**AP - 59**

**GENERAL  
CORRESPONDENCE**

AP-59  
Gen. Cor.  
2007-2004

RE: F-35 SWD & G-35 SWD, T17S, R35E; NMOCD Case #: AP-59, Quarterly Report

<b>R.T. Hicks Consultants, Ltd</b> 901 Rio Grande Blvd NW Suite F-142 Albuquerque, NM 87104 505-266-5004	ROC , G-35 Sites	<b>Figure 1</b>
	Monitoring/Recovery Well Boring	March 2007

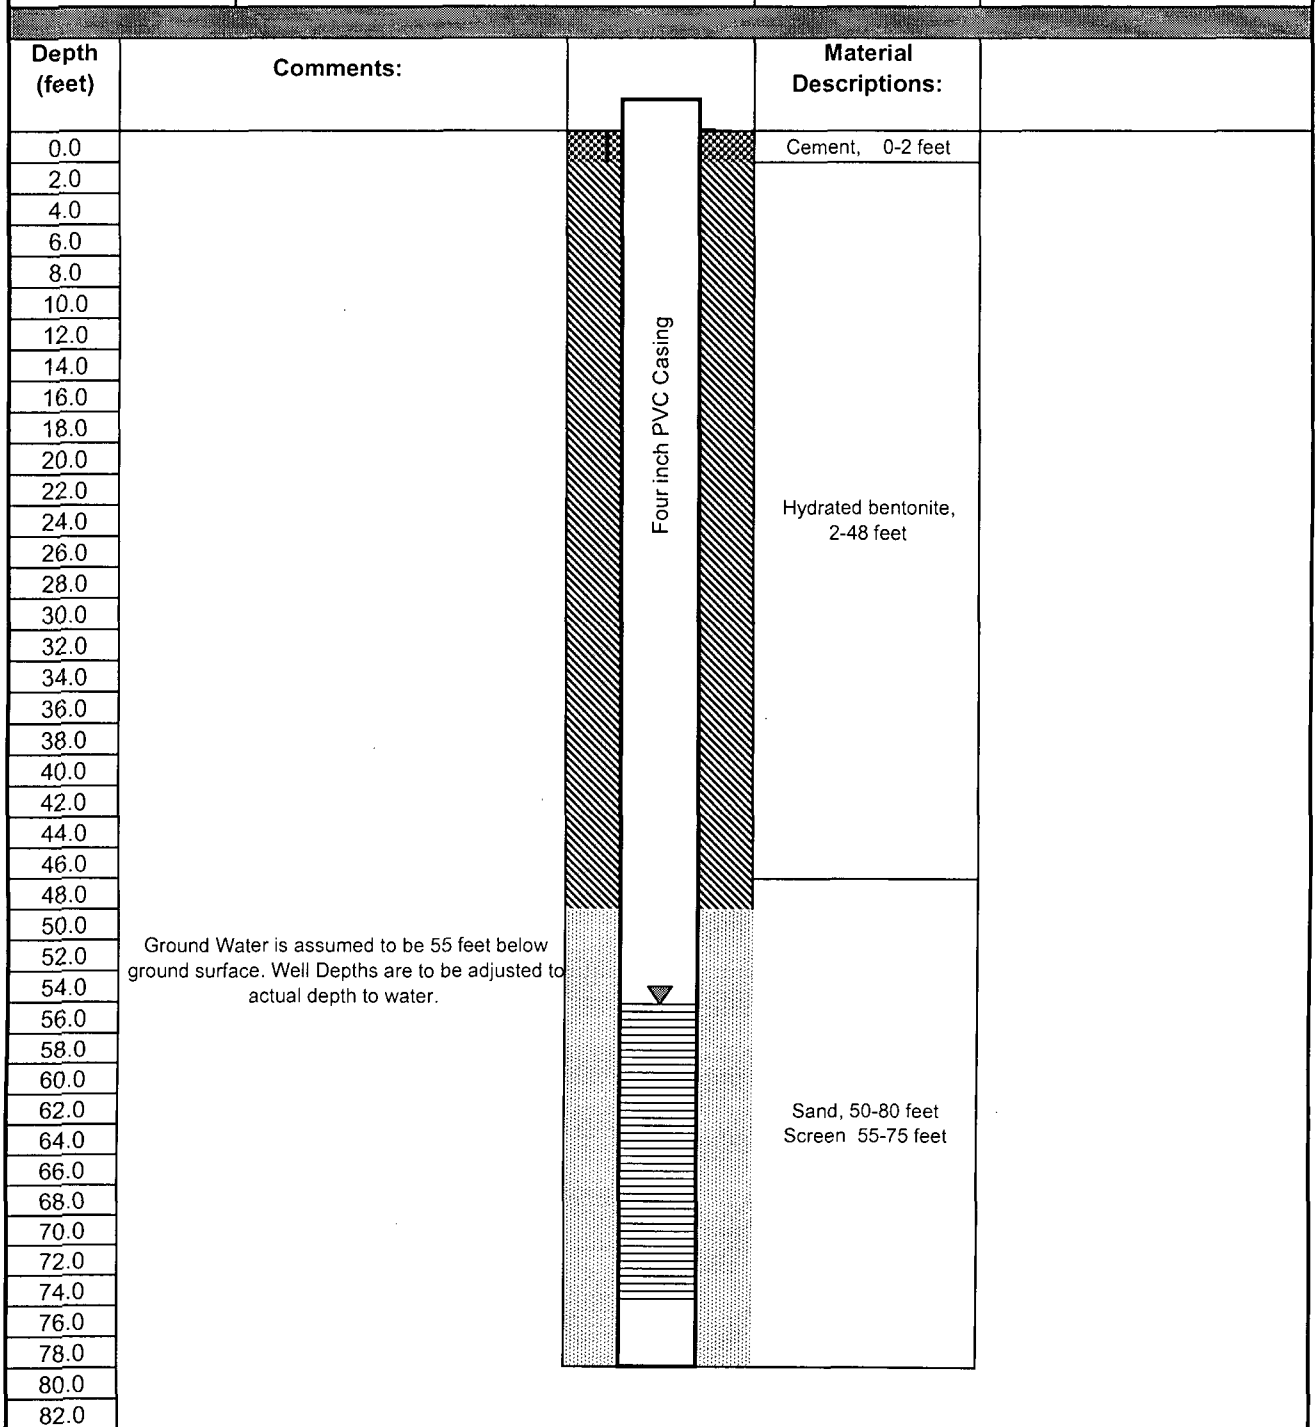
1. *Prior to implementing the proposed [vadose zone] remedy, Rice Operating Company (ROC) must provide soil sample analytical results for chloride from at least one boring in the center of each excavation at each of the two sites. The borings must be advanced to groundwater with soil samples taken at 5 feet intervals.*

Collection of soil data to within 5-feet of the water table will provide excellent data without creating a potential direct conduit between chloride in the vadose zone and the aquifer. Collapse of the borehole during sampling or drilling could create such a conduit.

- collect 2-3 samples from each boring for laboratory analysis of soil moisture
- record observations of the physical nature of the vadose zone on a boring log
- construct a 4-inch recovery well at G-35 near the excavation using the well design shown in Figure 1 (attached).

**Figure 1: Vadose Zone Water Flux into the Aquifer with Different Thicknesses of ET Barriers, F-35 and G-35 Sites**

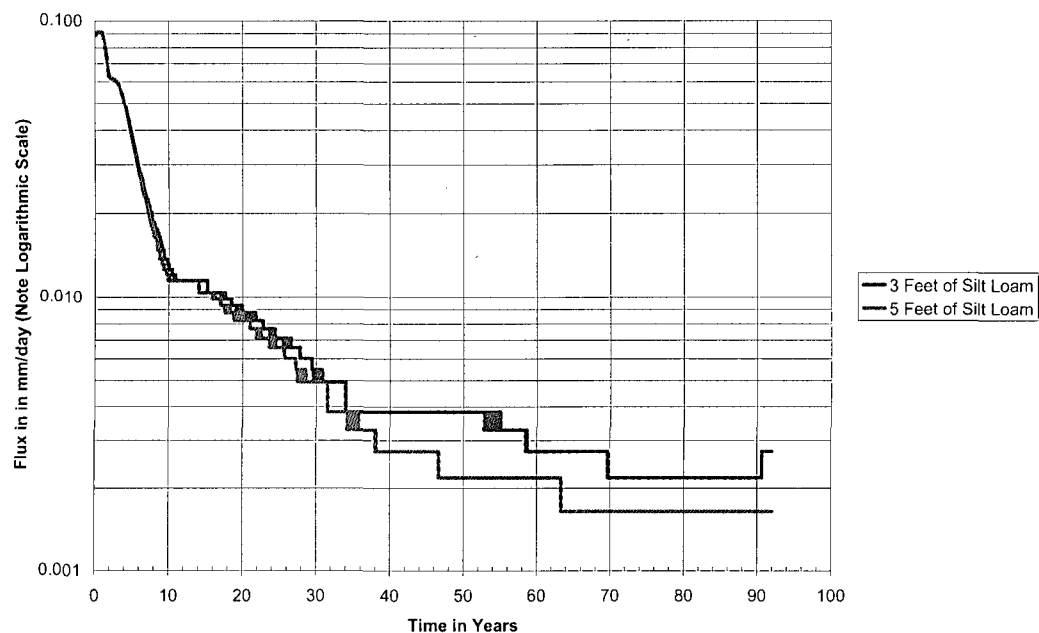
Our recent work shows that the native soil in the area is only several inches thick. As a lot of material from the site excavations was off hauled years ago, there is insufficient material at either site to use in the proposed capillary break or ET barrier. We propose to purchase and import sand and gravel as well as silty loam from the nearby surface owner for use as the capillary break and ET barriers in the excavation caps. During installation of these materials we will conduct a sieve analysis to and provide the results to NMOCD. We will compact the soil layer of the ET Barrier to 85-90% proctor density and provide field tests to demonstrate that construction is consistent with this design criteria.

We used HYDRUS-1D simulations to test the relative efficacy of a 3-foot thick and a 5-foot thick ET Barrier. The results show that a 5-foot layer does not perform measurably better than a 3-foot layer. We attach an explanation of this modeling effort in which we present the input data for these simulations and describe the simulation methods. Table 2 presents the predicted increase to ground water chloride concentration beneath 3-foot thick silt loam and 5-foot thick ET Barriers with a capillary barrier. In both cases, it is assumed that the root zone penetrates the full depth of the ET Barrier. The simulation assumed that the excavations are filled with appropriate materials to construct the caps and compacted to the proper density. Below the ET Barrier, the model assumed a zone of relatively moist sand-caliche with a constant chloride concentration existed from 10 feet below ground surface (bgs) to 20 feet bgs

With both ET barrier simulations, infiltration is decreased resulting in lower vadose zone moisture contents and corresponding decreases in hydraulic conductivities (See Figure 1).
